Docket Nos. 50-352
50-353

Subject: Limerick Generating Station (LGS)-Units 1&2
Open Items from NRC Draft Safety Evaluation
Report (DSER) - Structural Engineering
Branch (SEB)

ENCLOSURE 1
Response to LGS DSER-SEB Open Item Numbers 1, 4, 8, and 9

FIGURE (SER-1-1)

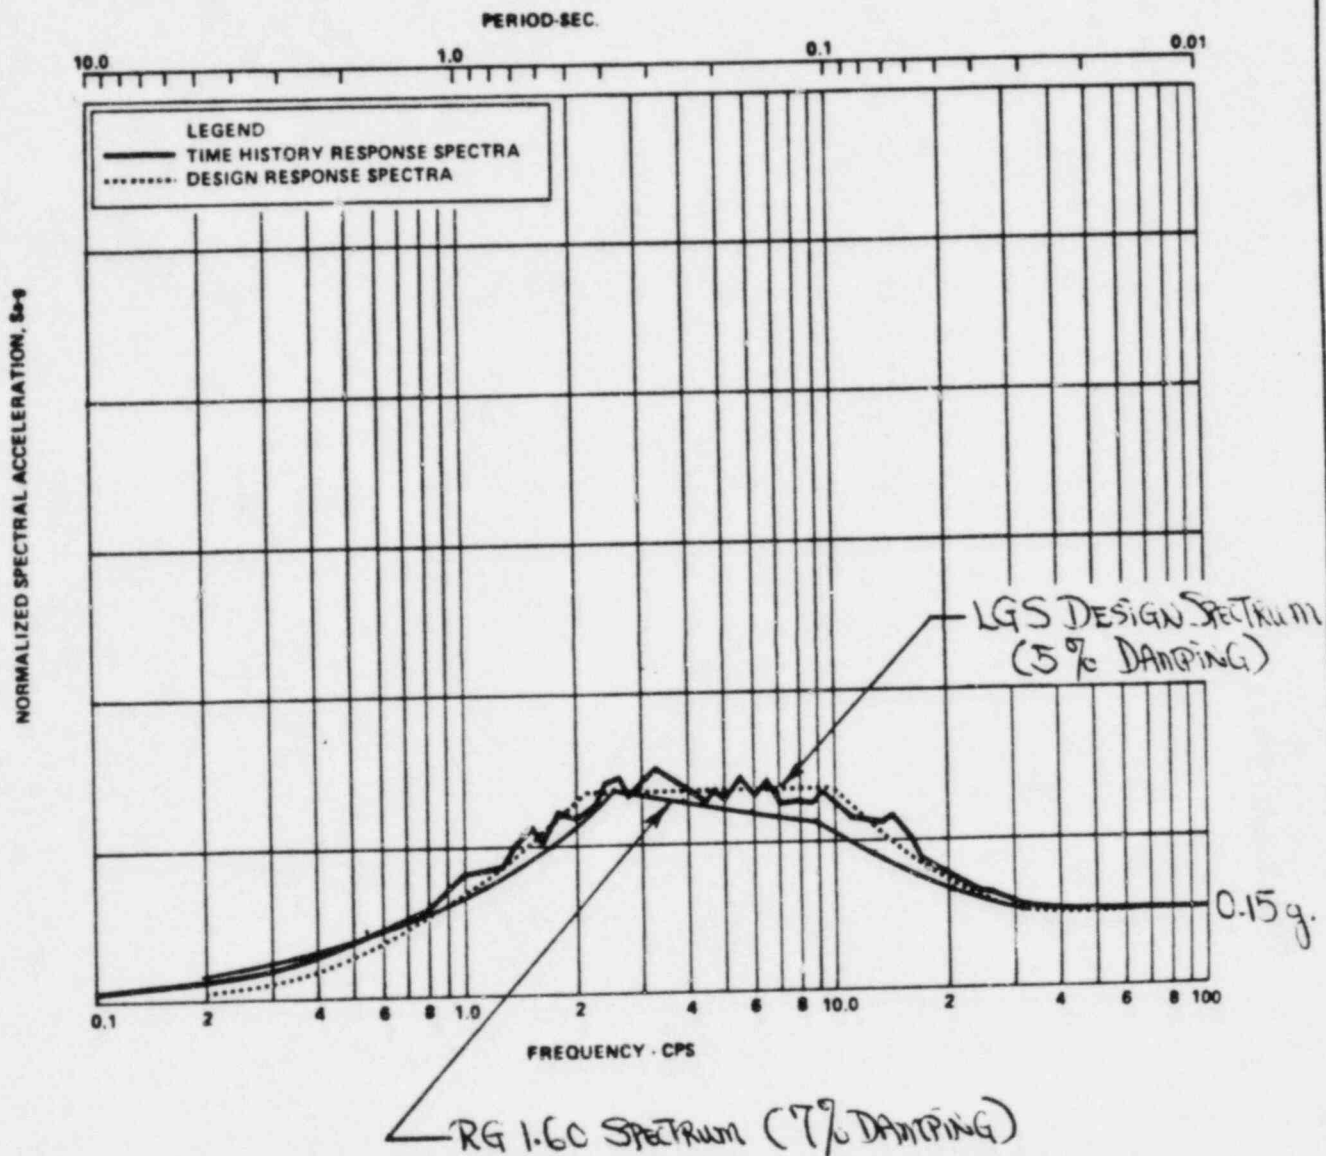
Comparison between the LGS design response spectra and R.G. 1.60, "Design Response Spectra for Seismic Design of Nuclear Power Plants", indicated that for frequencies between 1 hz and 5 hz, R.G. 1.60 exceeds the LGS design spectra. The applicant should discuss the significance of these exceedances on structures, piping, equipment and systems essential for the safe shutdown of the plant. The staff considers this to be a confirmatory item.

For comparison, the horizontal LGS design spectra are plotted with the RG 1.60 horizontal spectra in figures SER-1-1 and SER-1-2. These plots show that both the OBE and SSE horizontal LGS design spectra envelop the RG 1.60 spectra for frequencies greater than 1.0 hertz.

CONTAINMENT MODEL - VARIATION IN DIAPHRAGM SLAB SPRING STIFFNESS

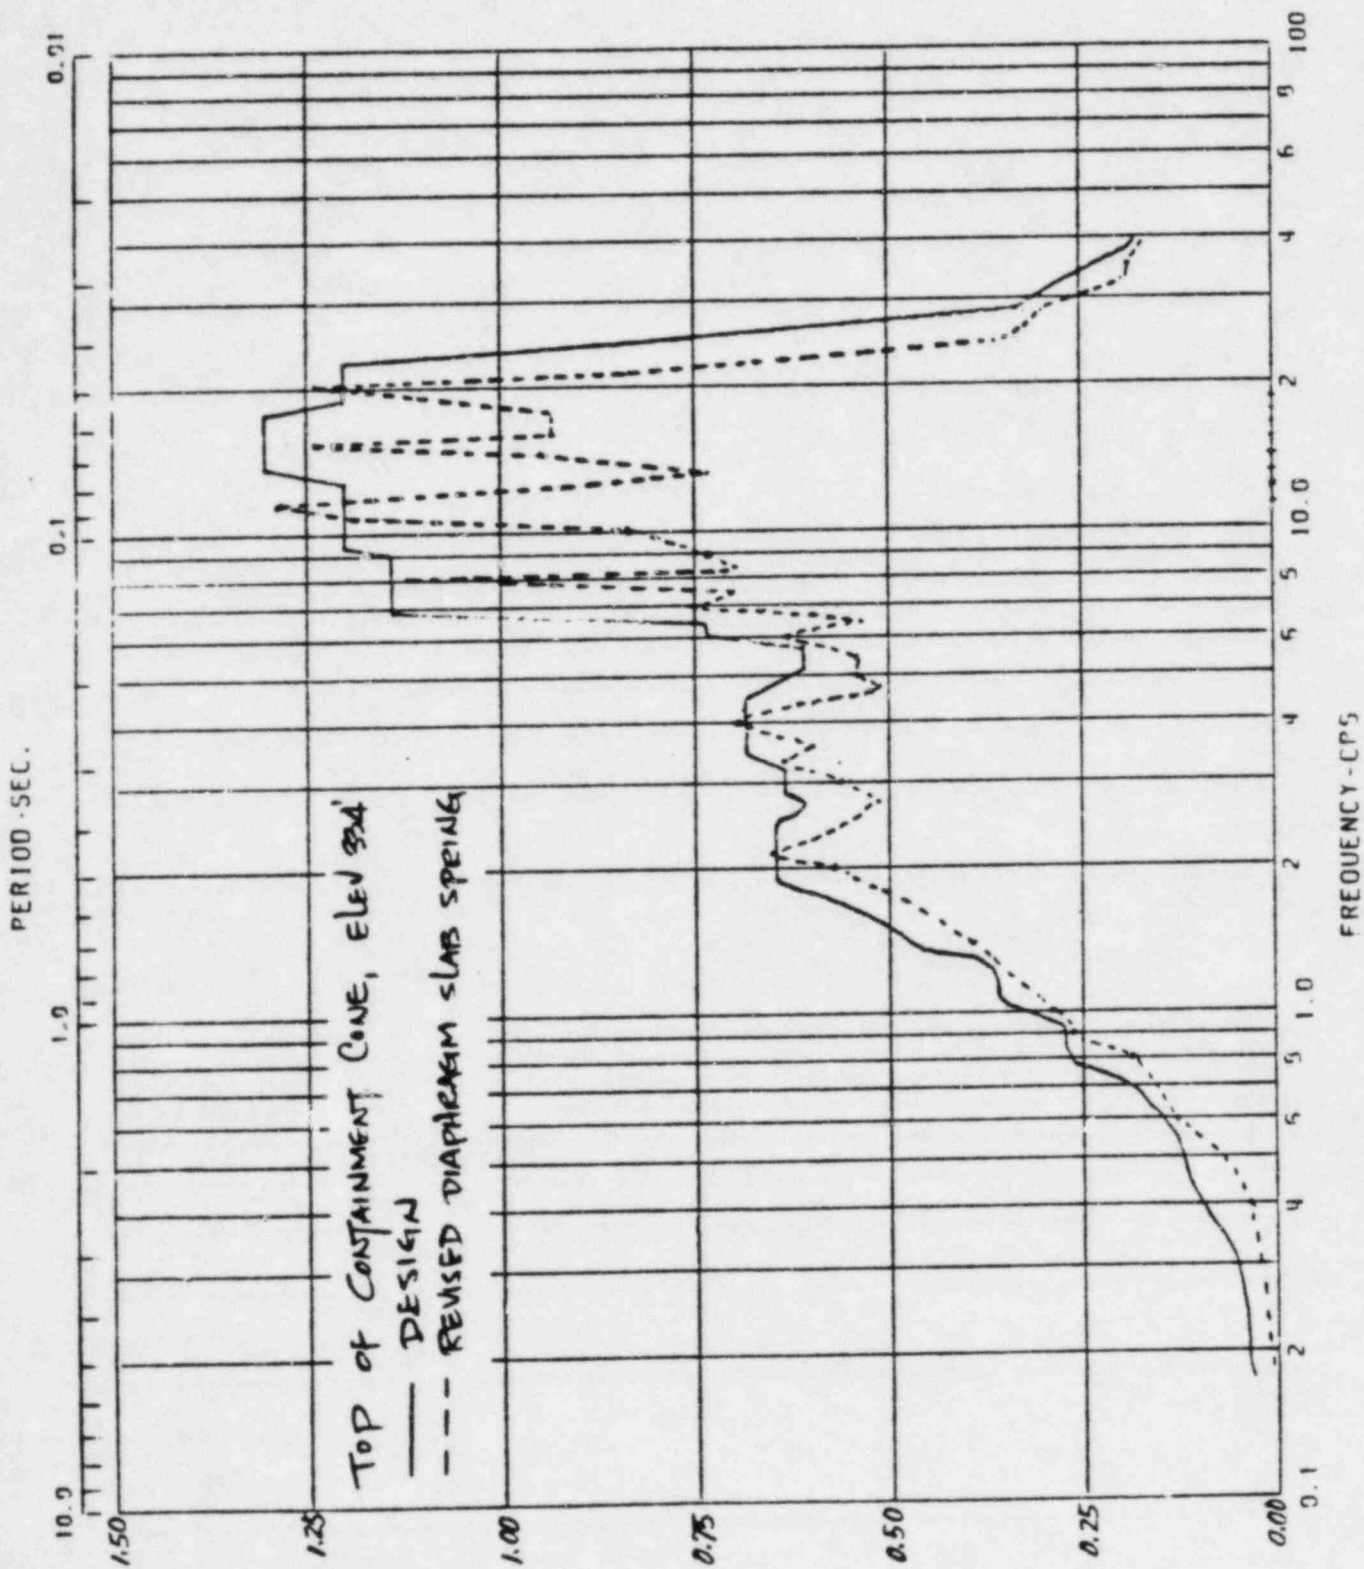
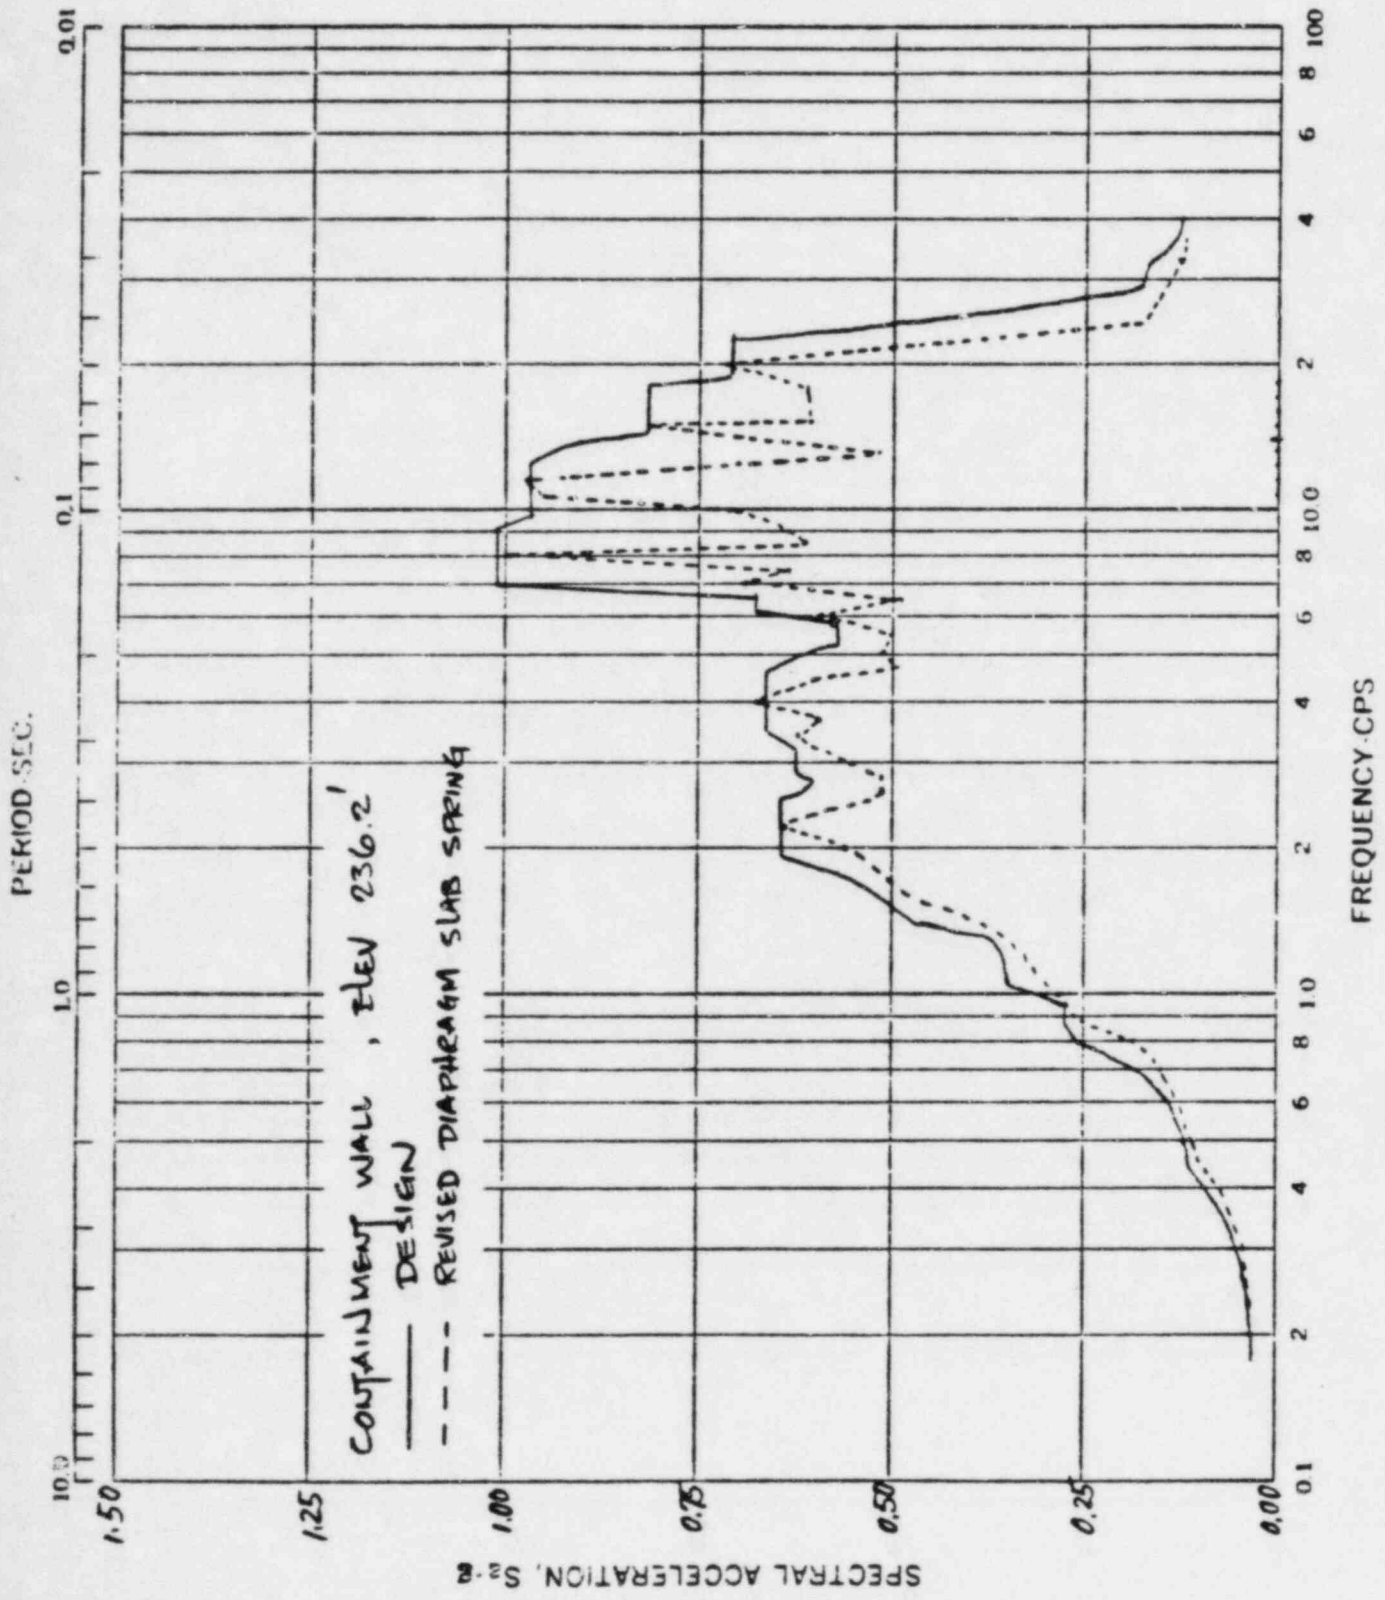
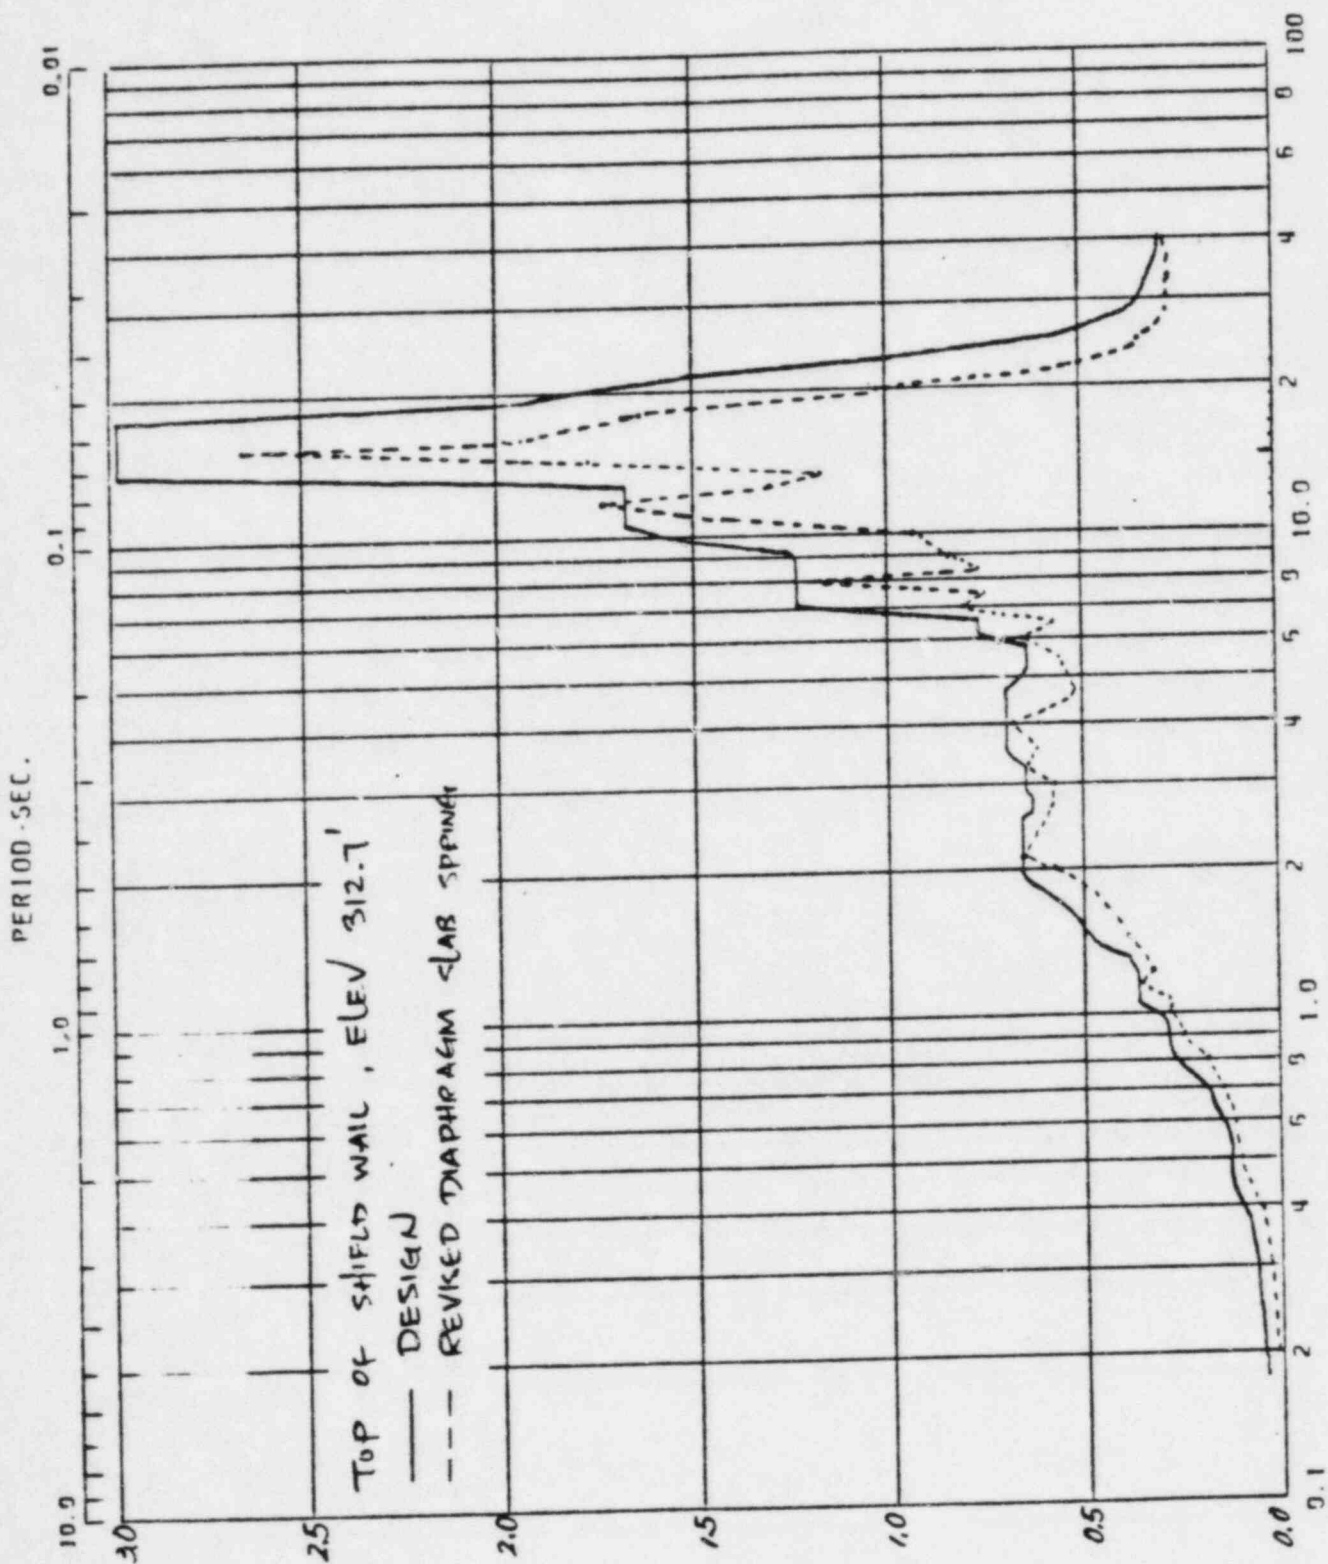
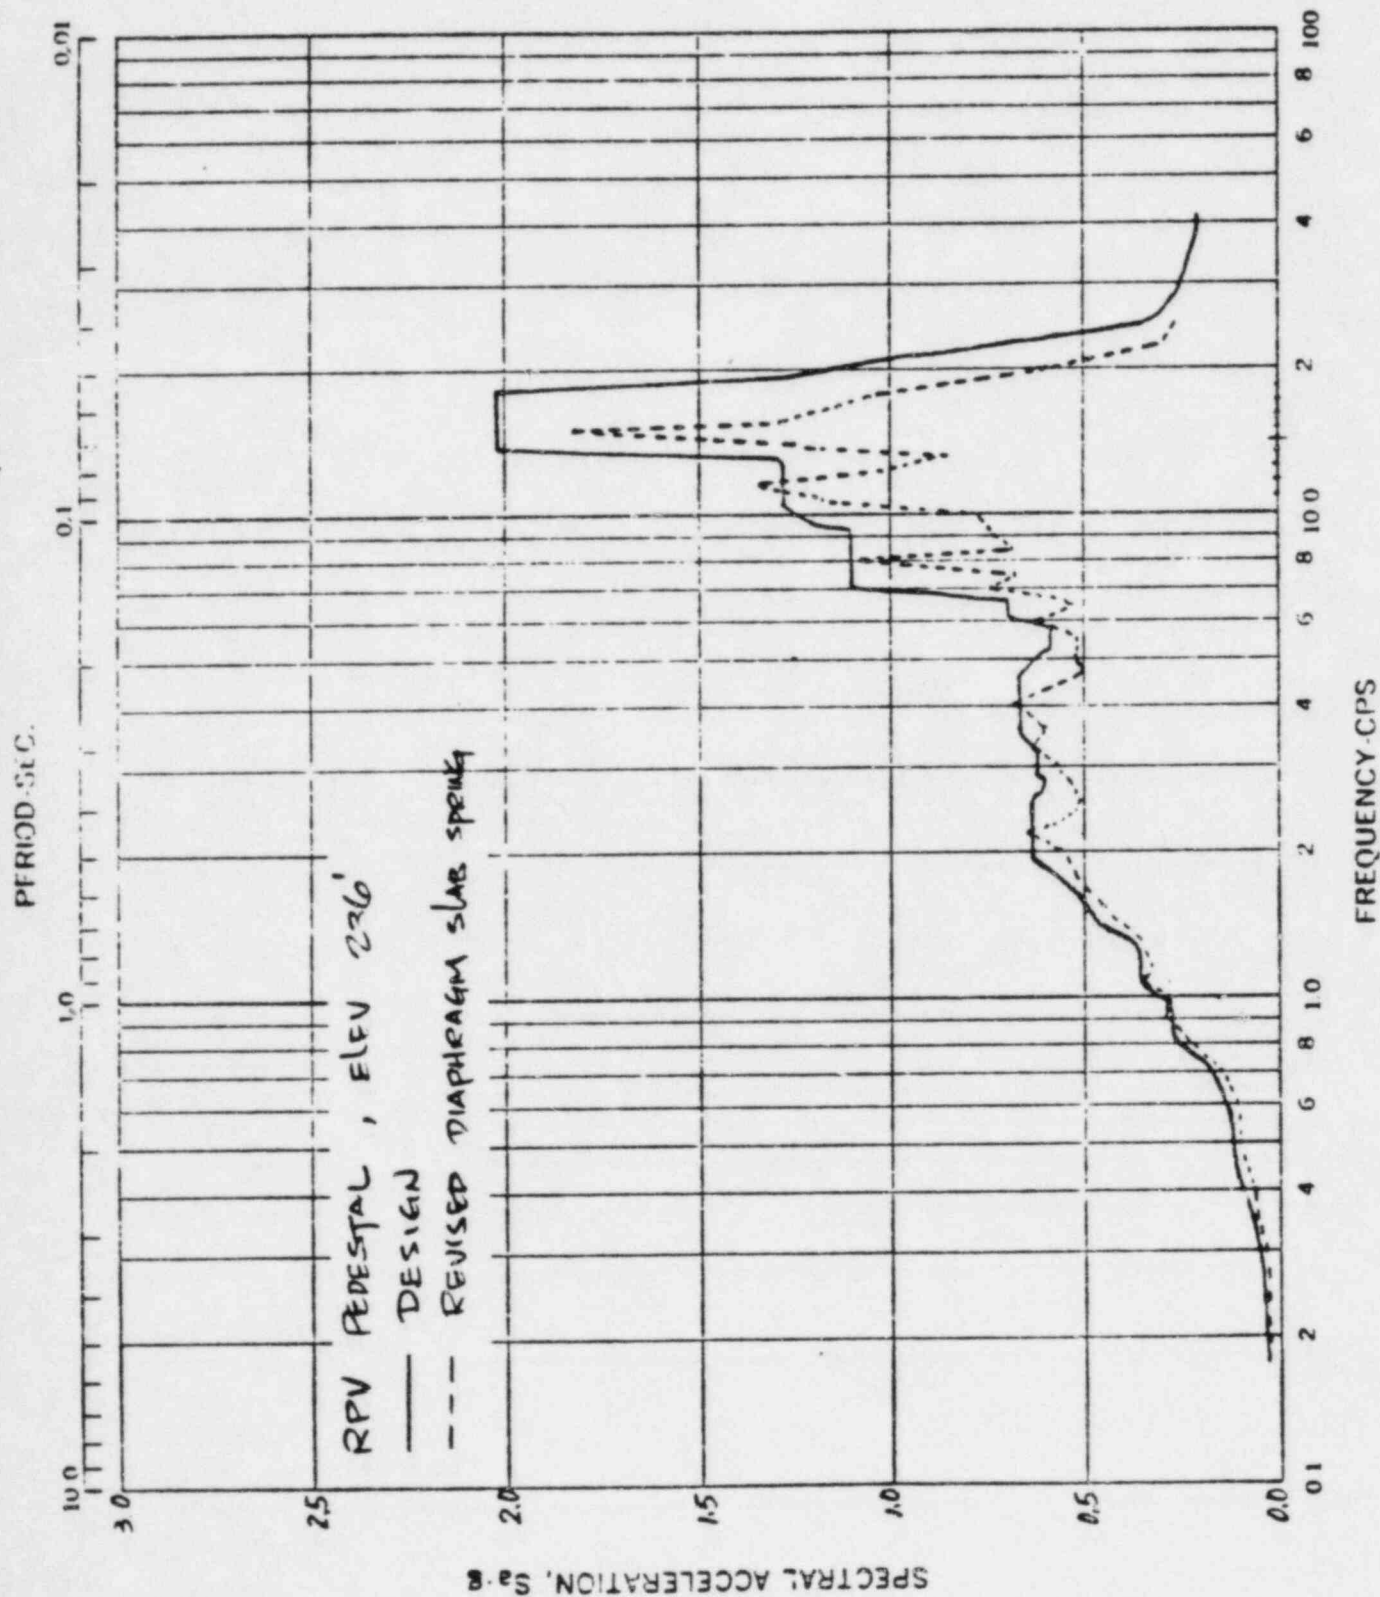
In addition to the problems with the rock parameters mentioned in (3) above, a structural design audit performed by the staff revealed problems with the containment dynamic model. These problems consist of errors in calculating the containment diaphragm slab spring stiffness and mass distribution of the containment building floors. The staff considers these problems to be open issues.

The diaphragm slab is rigidly connected to the containment wall and the reactor pressure vessel (RPV) pedestal wall. Hence, the equivalent spring representing the diaphragm slab in the vertical containment model is calculated using a fixed-fixed boundary condition. The error* in calculating the equivalent spring stiffness has been corrected.

The containment vertical uncracked seismic model has been reanalyzed with the new corrected spring stiffness for the SSE event. Comparisons of modal frequencies, modal participation factors, and selected acceleration response spectra between this revised spring model and the design model are presented in attachment 1. From these comparisons, it is concluded that:

- a. Adjustment of the spring stiffness of the diaphragm slab induced negligible variation in the structural response for the containment structure, and
- b. The current seismic analysis of the containment structure is adequate.
